ADDENDUM #2
Staunton Bridge Community Center Gymnasium
IFB# 68-05/02/16

ISSUED: April 26, 2016

ROOF
FRAMING PLAN

S-103

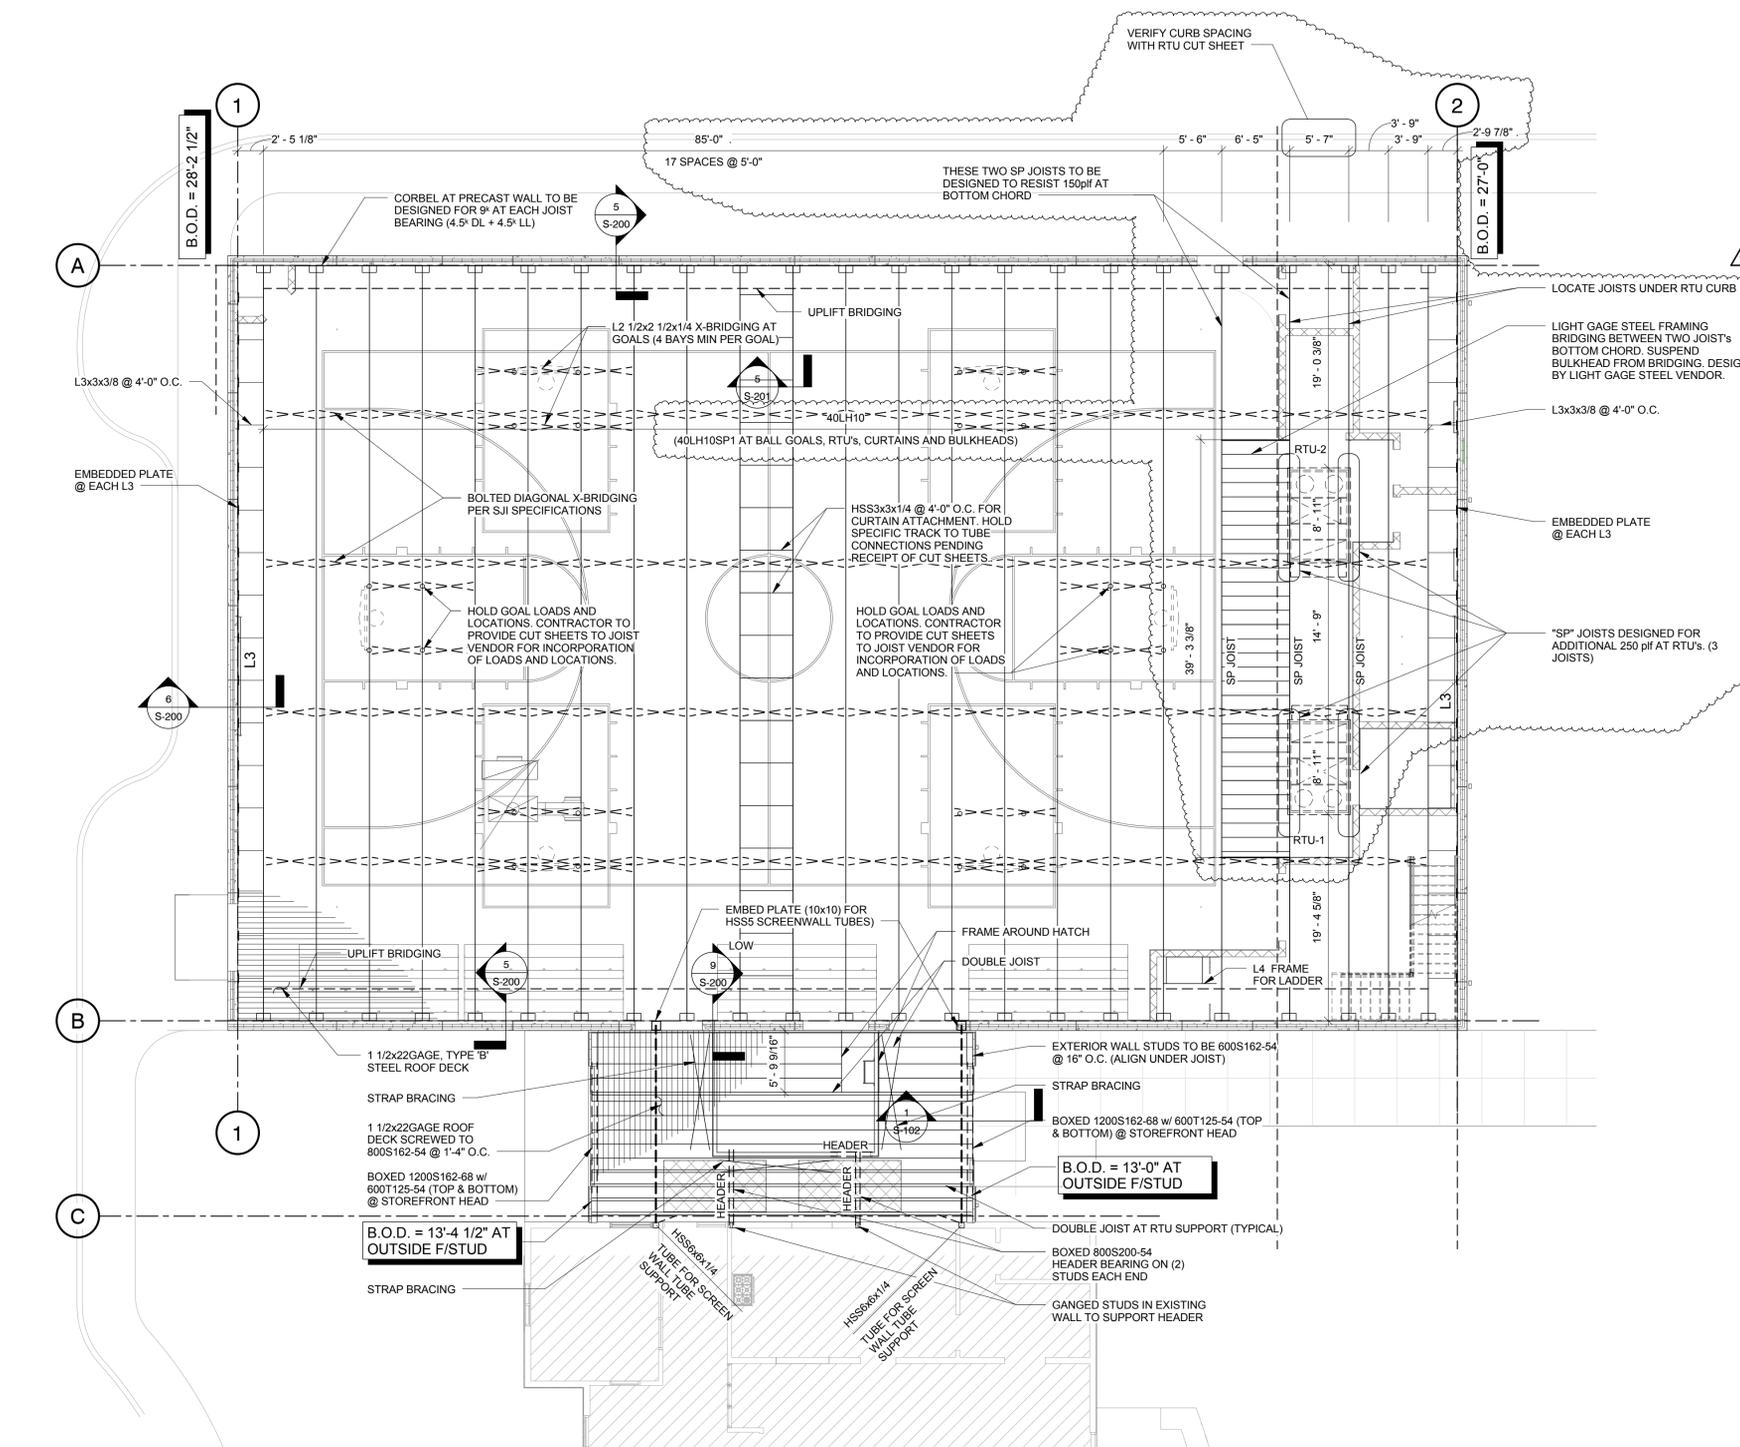
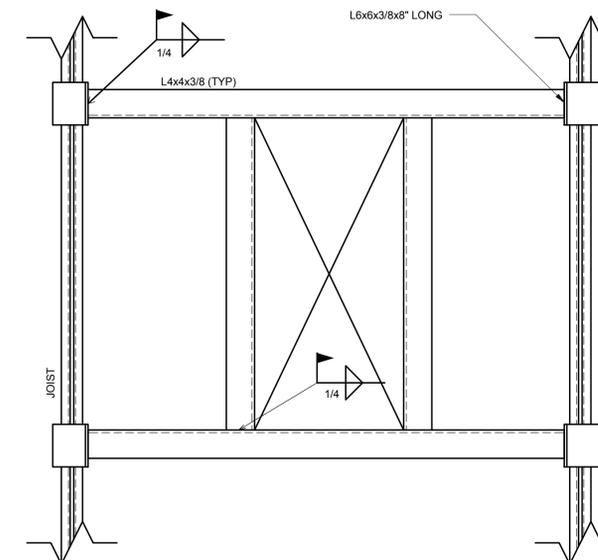
- 4. The attached S-103 Sheet shall replace the S-103 Sheet in the drawings. Extra support has been added to accommodate the gypsum board bulkhead outside the restrooms and the structural roof joist spacing was adjusted to accommodate the new roof top units.**

PROVIDE L2 WHERE A POINT LOAD GREATER
THAN 100# WILL BE IN PLACE 6" AWAY FROM
PANEL POINT

PROVIDE L4 UNDER ALL EDGES OF RTU,
AROUND DUCT PENETRATIONS, AND AT
EDGES OF HATCH. PLACE VERTICAL LEG
OF L4 AT THE INSIDE EDGE OF RTU CURB.
LOCATE USING CURB CUT SHEETS.
